BLUE BIRD

CSC-10043404-4516

Models Affected: 2010-2011 All American (D3RE) with Cummins ISC Engines

ISSUE

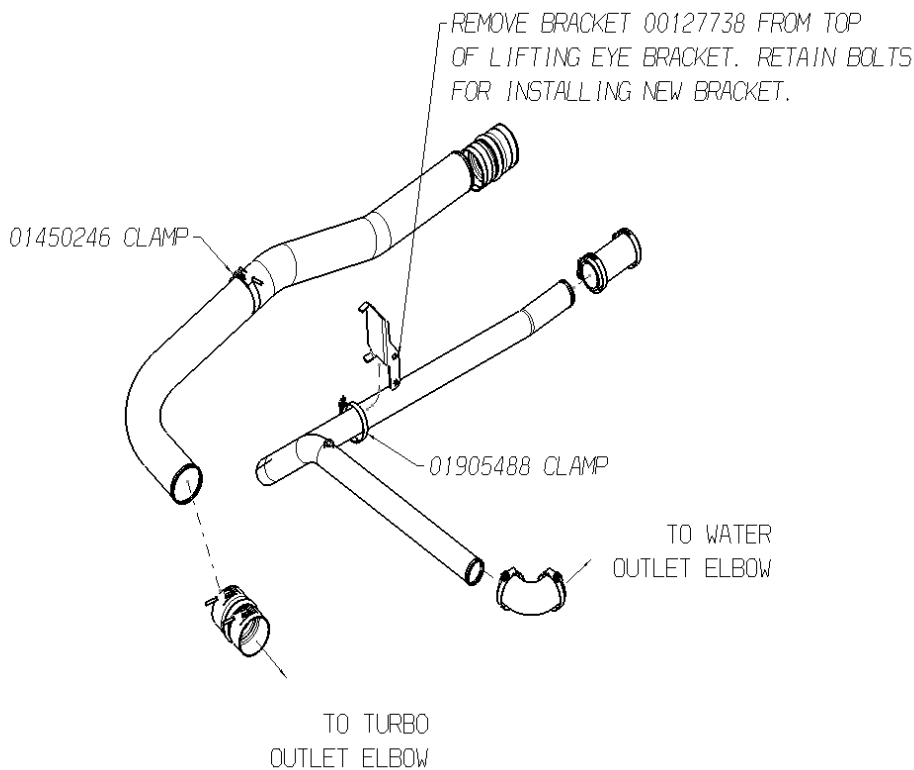
Charge air cooler tube support bracket may fail.

Replace original charge air cooler tube support bracket with new bracket.

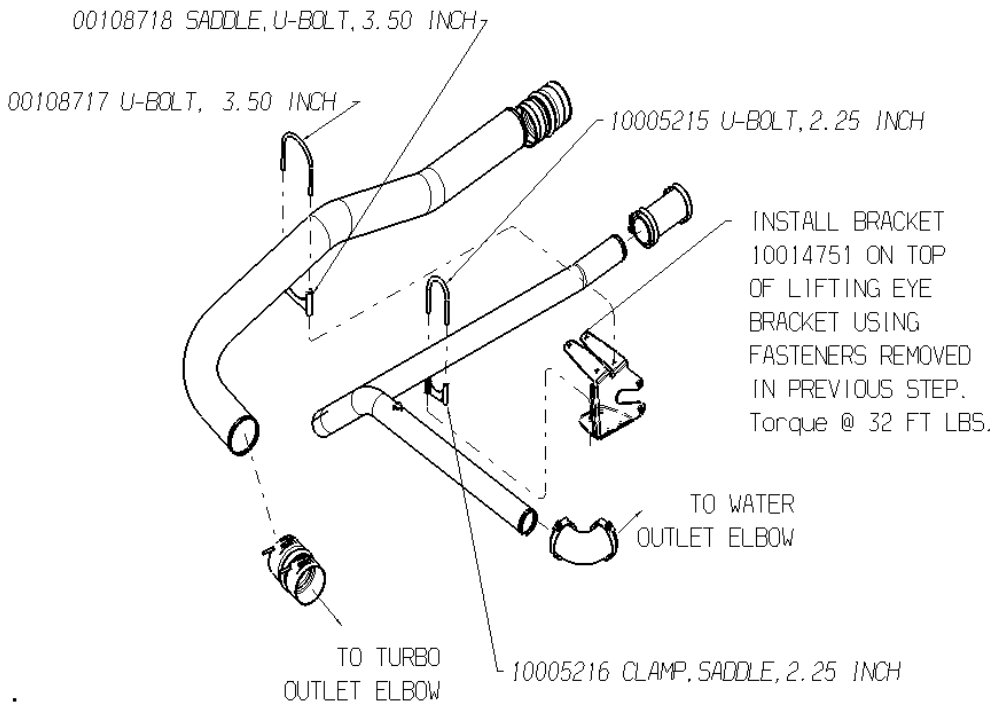
1. Park the bus on a level surface, apply parking brakes, turn off engine and remove keys. Chock wheels.
2. Remove existing charged air cooling tube support bracket, part number 00127738, and the related clamps per diagram below and discard. Retain fasteners to engine for use with new bracket.

3. Install new charged air cooling tube support bracket, part number 10014751, and the related clamping components per diagram below.
